DOVER LOCAL PLAN EXAMINATION

KENT DOWNS AONB UNIT

MATTERS ISSUES AND QUESTIONS

Matter 3 – Housing Allocations

Figure 3 – Contour map

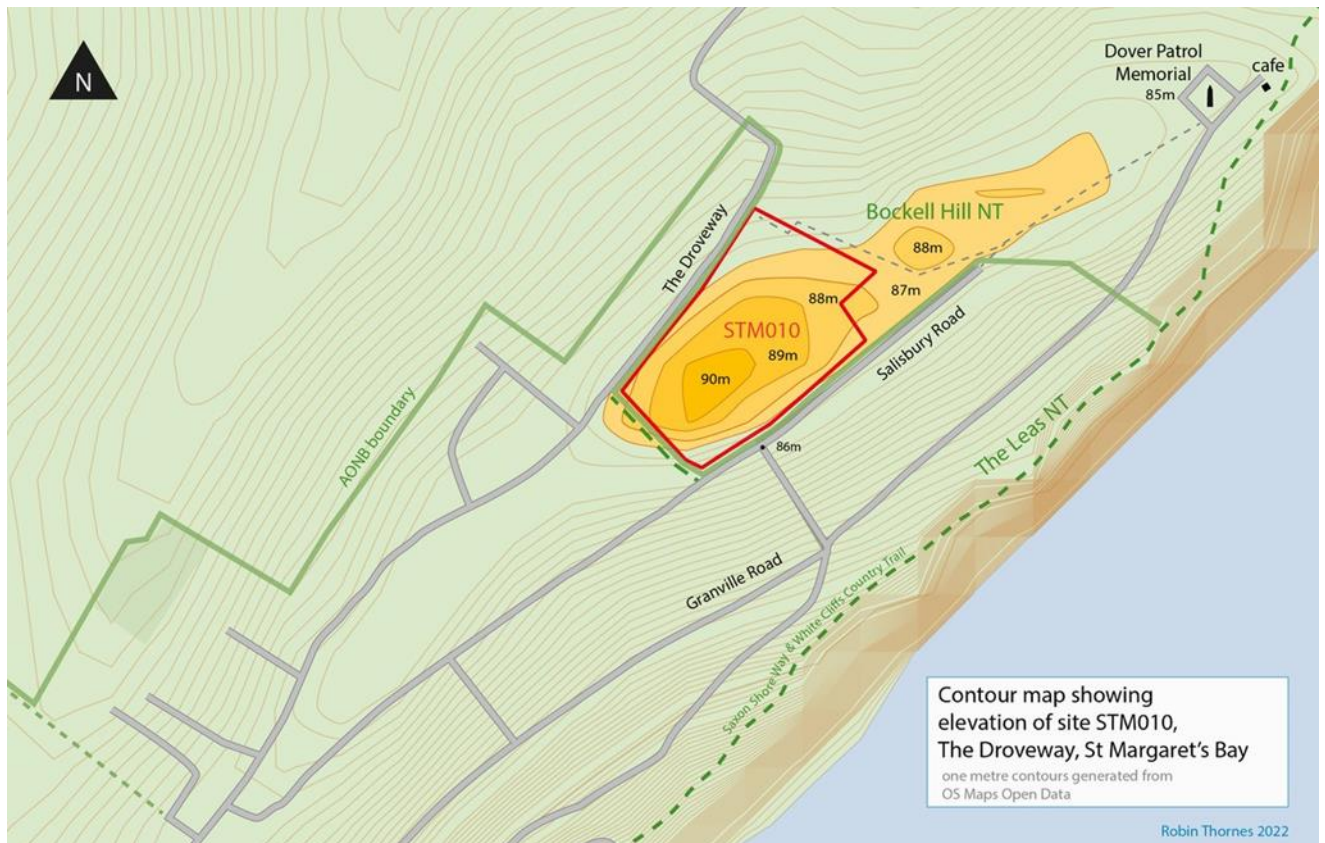
The AONB Unit considers the contour line map below in Figure 3 below (taken from the Regulation 19 Submission of The St Margaret's at Cliffe Residents Group) is much more helpful in illustrating the height of the site relative to surrounding land and existing development. It shows that the site is higher than all surrounding land, not just the housing to the southwest as advised in the LVS. This demonstrates that existing built form in Salisbury Road is built at the 84 to 85m contour line while that in The Drove opposite the site is at 86m at its highest at the southwestern end, reducing to 83 metres at the northern end opposite the site. In contrast, the majority of the proposed allocation is in the 87m to 90 metre contour range (as can be seen in Fig 1 below there are small areas of lower pockets of land in the south western and northern corners of the site) and allowing for a driveway set back, any built development would be likely to be built at a minimum of 88 metres and as a result much more prominent in the landscape than existing built form in a part of the Kent Downs AONB that is recognised as having particular visual sensitivities.
